SUPPLEMENT
28 November 1951

SUPPLEMENT TO
TM 11-2234
TELETYPEWRITER TT-4/TG

The following information, published on Order No. 1671-Phila-51, supplements TM 11-2234, April 1951. The serial numbers of the equipment covered in this supplement are:

Figure 49. Teletypewriter TT-4A/TG, schematic diagram.

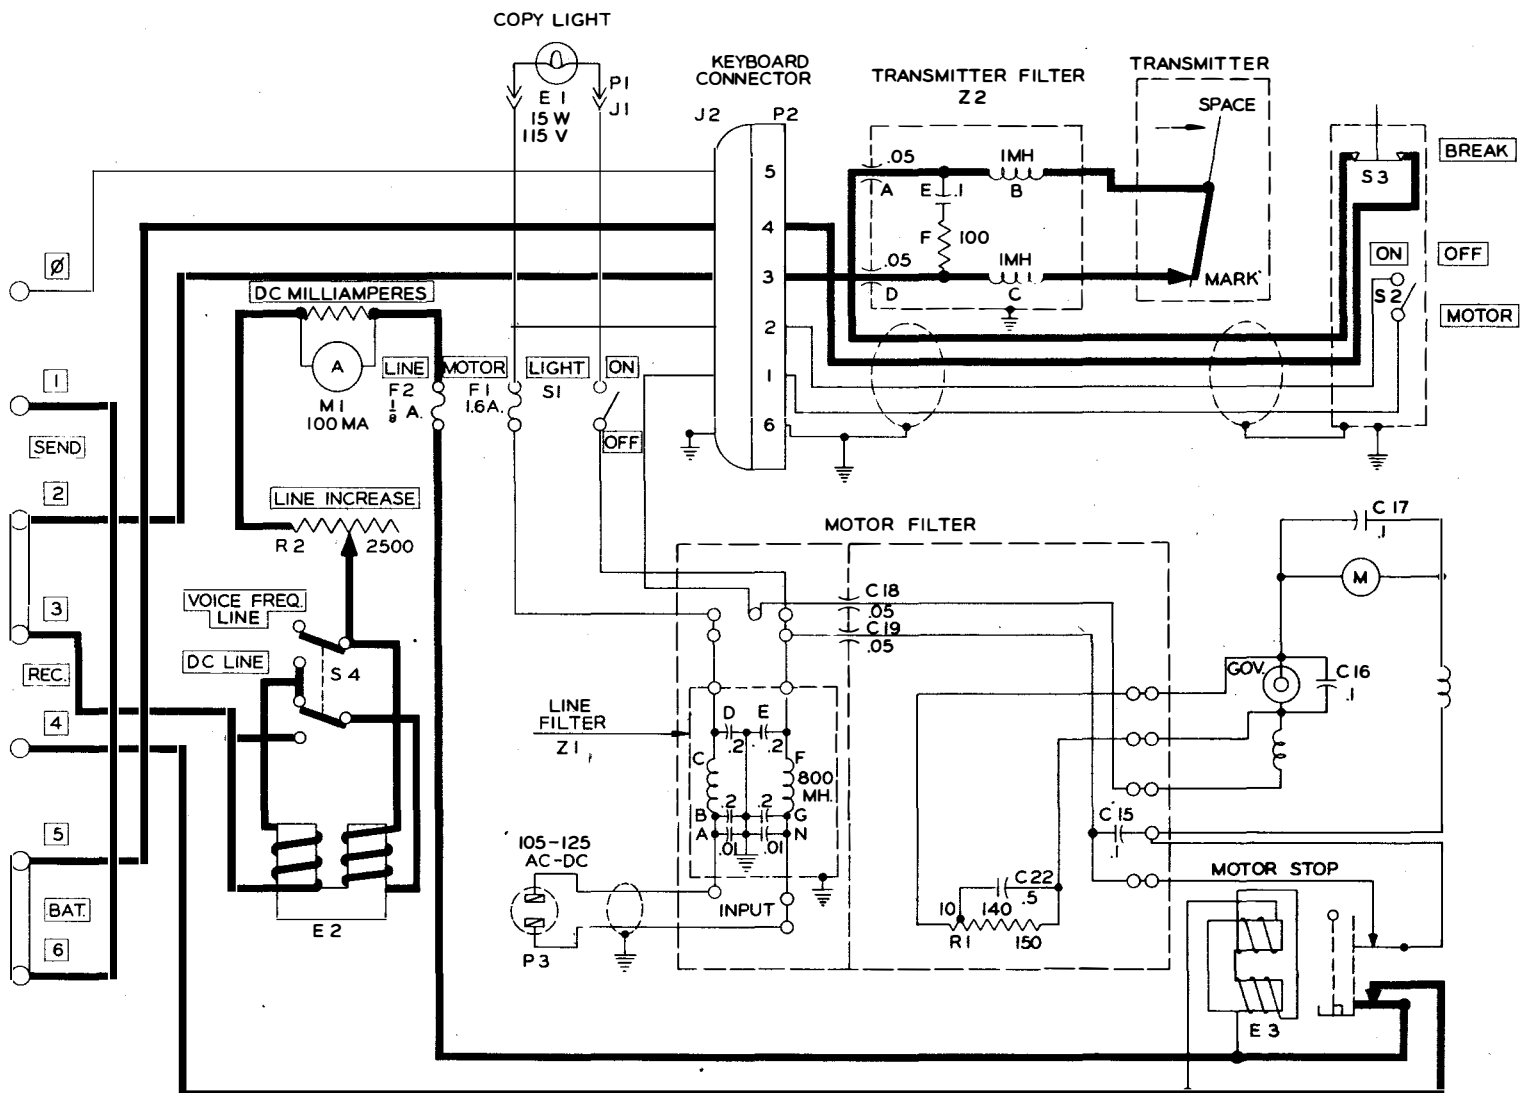
Page 82. Fig. 49. Delete figure 49 and insert new figure 49.

Figure 78.1. Carriage-feed blocking mechanism.

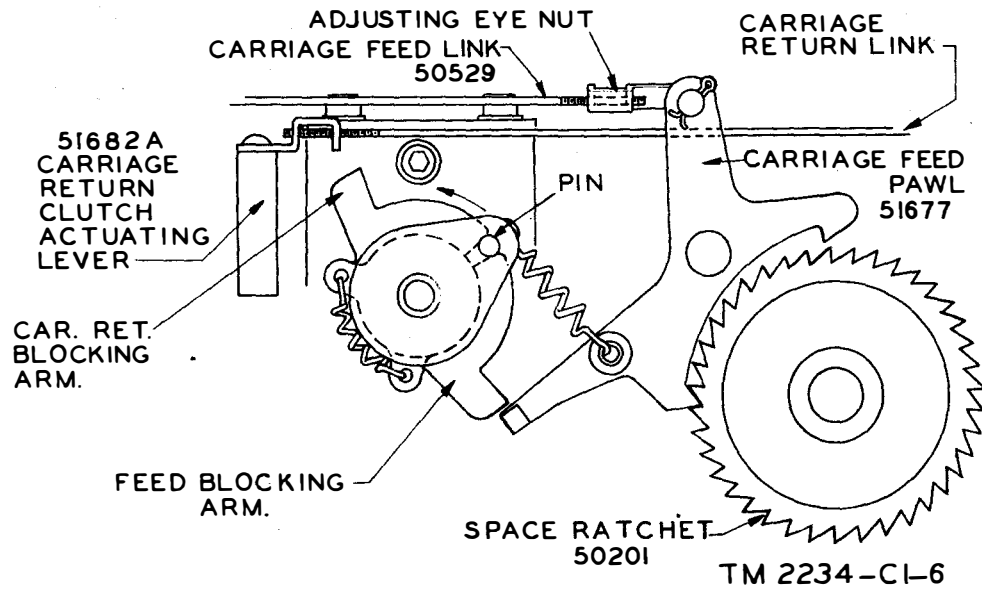
Page 104. Fig. 78. Insert figure 78.1 after figure 78.

e. Teletypewriter TT-4A/TG is provided with a blocking means for preventing the engagement of the carriage feed clutch if the carriage is in its extreme right-hand position. Figure 78.1 shows this means. As the carriage moves into the 72*d* space, the lower edge of the carriage-feed pawl moves between two of the teeth on the space ratchet and the carriage-feed blocking arm engages the feed pawl so that it cannot release the ratchet to engage the feed clutch. This prevents undue strain on the carriage-feed shaft and gears should another key be struck before the carriage-return key is operated. If another key is so operated, the printed characters will be printed on top of each other. If 76-characters-per-line operation is desired, the pin may be turned 90° to increase the separation of the blocking arms.

Figure 79.1. Carriage-return blocking mechanism.

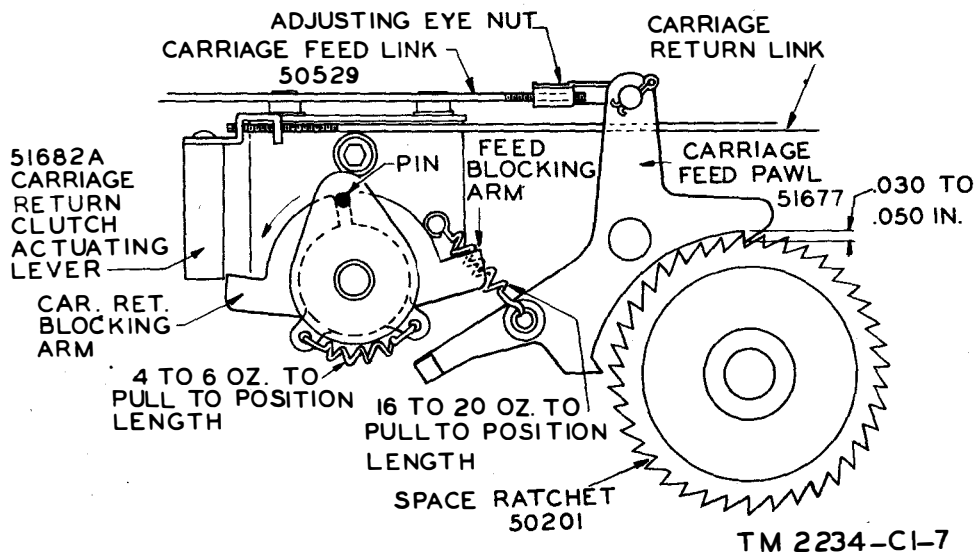
Page 105. Fig. 79. Insert figure 79.1 after figure 79.

g. The carriage-return clutch cannot be engaged when the carriage is in its extreme left-hand position because a portion of the carriage-return-clutch-actuating-lever will engage the end of a carriage-return blocking arm. The actuating clutch lever cannot move; therefore the clutch cannot be en-

gaged. As soon as the carriage is moved one space, the carriage-return blocking arm (fig. 79.1) moves downward enough to clear the end of the clutch-actuating-lever so that it can move (if a carriage-return signal is received) sufficiently to operate the carriage-return clutch.

Figure 81. LINE FEED mechanism.

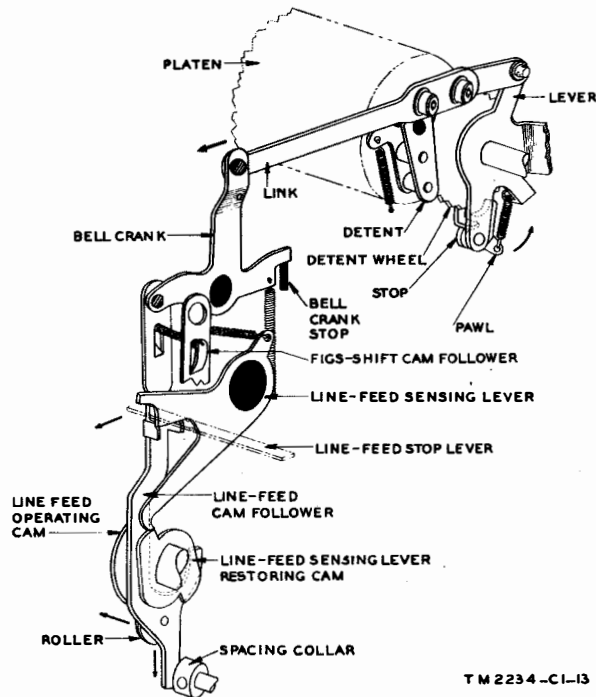
Page 109. Fig. 81. Delete figure 81 and insert new figure 81.

Figure 82. FIGS-shift mechanism.

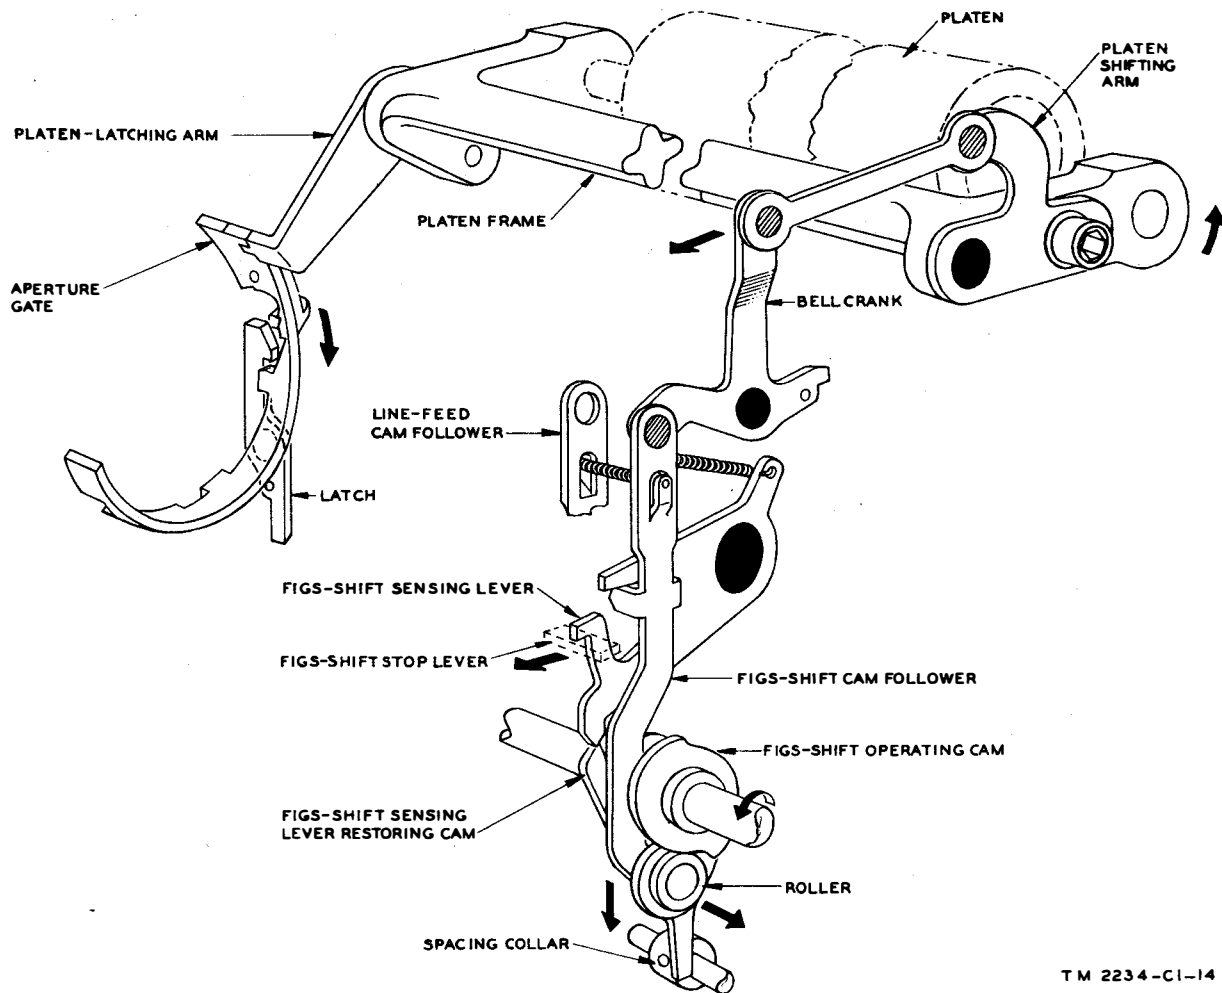
Page 110. Fig. 82. Delete figure 82 and insert new figure 82.

Figure 112. Transmitter Parts.

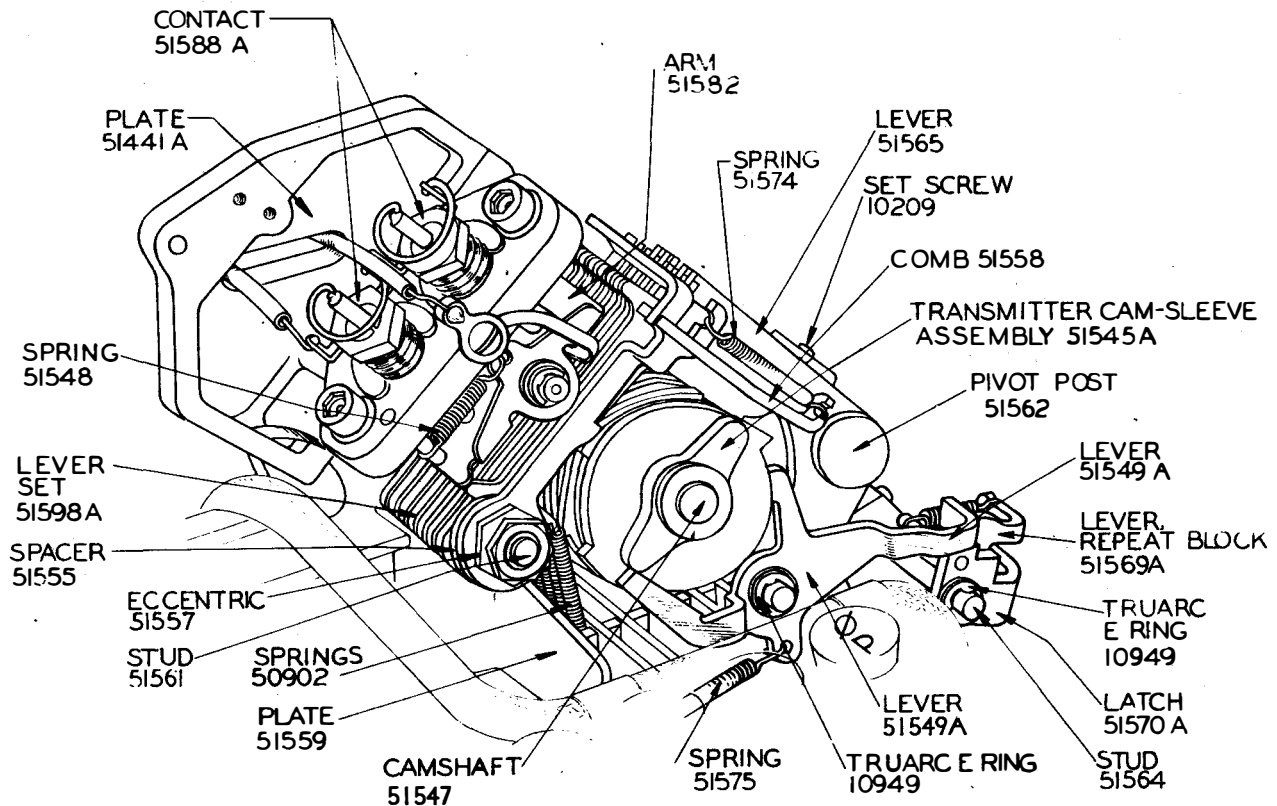
Page 146. Fig. 112. Delete figure 112 and substitute the following:

Figure 170. Platen in the FIGS-shift position, end view.

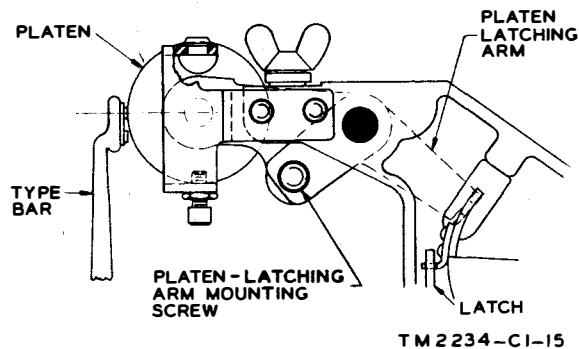
Page 181. Fig. 170. Delete figure 170 and insert new figure 170.

Figure 171. Platen in the LTRS-shift position, end view.

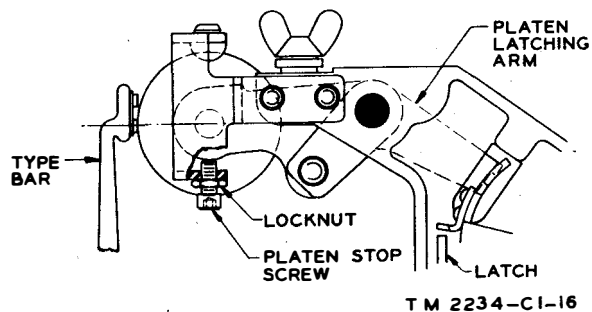
Page 181. Fig. 171. Delete figure 171 and insert new figure 171.

Figure 173. Platen-shifting mechanism, side view.

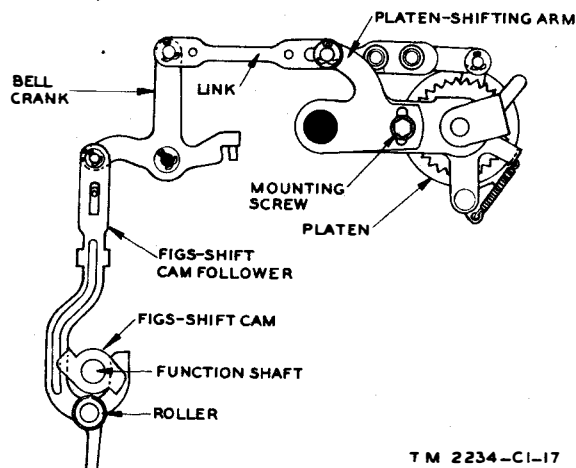
Page 182. Fig. 173. Delete figure 173 and insert new figure 173.

Figure 174. LINE FEED mechanism, side view.

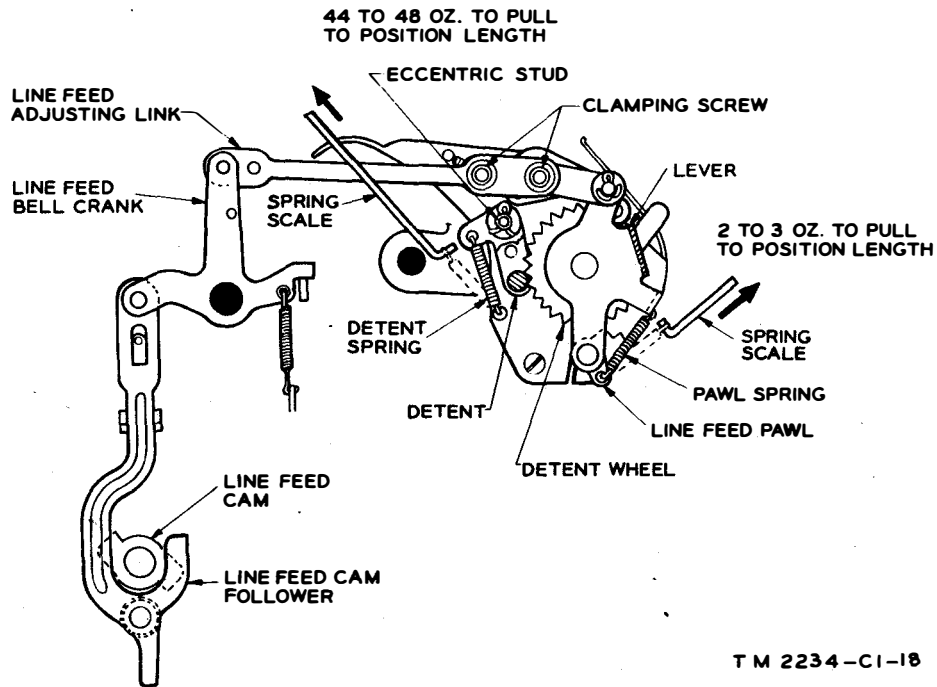
Page 182. Fig. 174. Delete figure 174 and insert new figure 174.

Figure 174.1. LINE FEED mechanism settings for Teletypewriter TT-4A/TG.

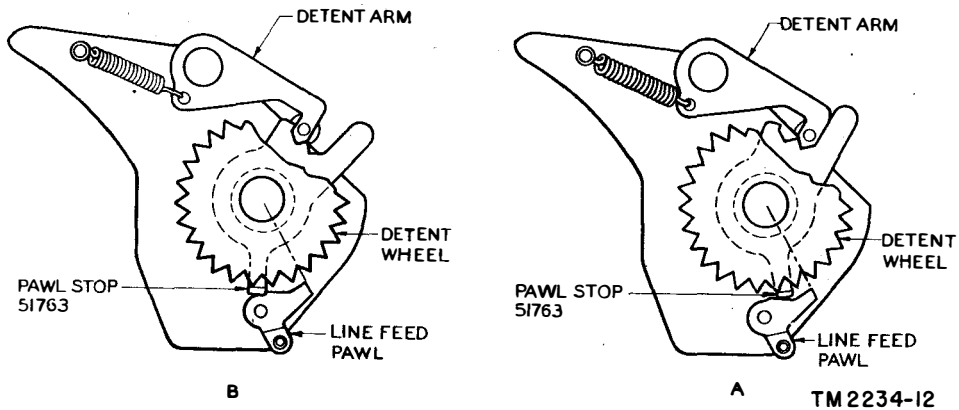
Page 182. Fig. 174. Insert figure 174.1 after 174.

Change the first sentence to read: The platen is turned to feed the paper one or two line spaces by the operation of the LINE FEED key, depending upon the position of the adjustable pawl stop. A, figure 174.1 shows pawl stop 51763 positioned for single-line spacing and B, figure 174.1 shows it set for double-line spacing.

Page 182. Par. 245. Add the following to subparagraph a: with the adjustable pawl stop in the position shown in A, figure 174.1 and two line spaces when it is in the position shown in B, figure 174.1.

Figure 181. Transmitter-friction-clutch adjustment.

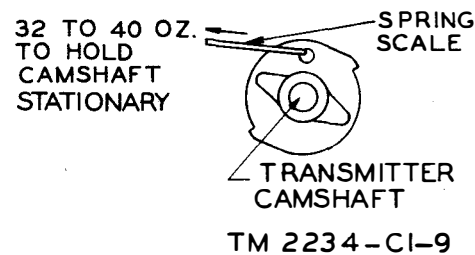
Page 186. Fig. 181. Delete figure 181 and substitute the following:

Figure 183. Universal-bar adjustment.

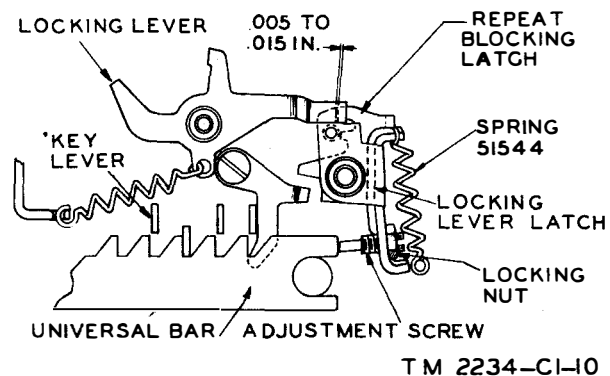
Page 186. Fig. 183. Delete figure 183 and substitute the following:

Page 186. Par. 263. In the first line of subparagraph *a*, change ".008 to .010" to read: .006 to .015.
